REMARKS

ANNOTATED SHEET
AMAT/6394/PPC/ECP/RKK
10/074,569
February 11, 2002
APPLIED MATERIALS, INC.
Apparatus and Method for Removing Contaminants from Semiconductor
Copper Electroplating Baths
Kovarsky, et al.

FIG. 2

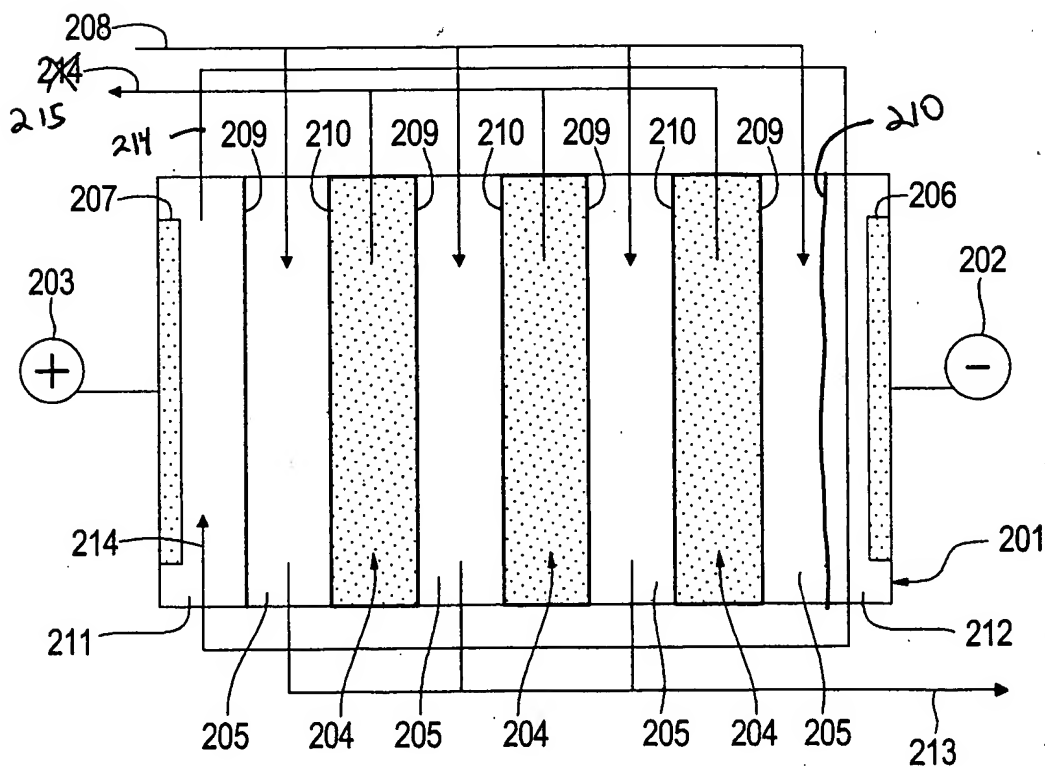
The drawings are objected to. Applicants have amended Figure 2 to correct the position of reference numeral 214. Applicants have added reference numeral 215 in Figures 2 and 3 to mark the fluid outlet of the concentration chambers, as described in original claim 20. An additional membrane 210 has been added to Figures 2 and 3 to separate the cathode chamber 212 and depletion chamber 205, as described in paragraph [0020] of the specification. The arrow head and lead line for reference numeral 212 have been joined in Figure 3, as requested by the Examiner. In Figure 4, a lead line has been added for reference numeral 403 to indicate the membrane closest to the anode (paragraph [0029]), as requested by the Examiner. In Figure 5, reference numeral 507 has been added to mark an additional membrane surrounding low concentration chamber 502, as described in paragraph [0034]. Also in Figure 5, the plus sign for reference numeral 504 has been changed to a minus sign, as supported by the specification's description of a cathode 504 in paragraph [0034]. The minus sign for reference numeral 505 has been changed to a plus sign, as supported by the

The attached sheets of drawings includes changes to Figures 2-5. These sheets, which include Figures 1-5, replace the original sheets including Figures 1-5. In Figure 2, the upper 214 reference numeral has been moved. Former upper 214 reference numeral has been changed to 215. An additional membrane 210 has been added to Figure 2. In Figure 3, reference numeral 215 has been added to mark outlet 215. An additional membrane 210 has been added to Figure 3. The arrow head and lead line for reference numeral 212 have been joined in Figure 3. In Figure 4, a lead line has been added for reference numeral 403. In Figure 5, reference numeral 507 has been added to mark an additional membrane. Also in Figure 5, the plus sign for reference numeral 504 has been changed to a minus sign, and the minus sign for reference numeral 505 has been changed to a plus sign.
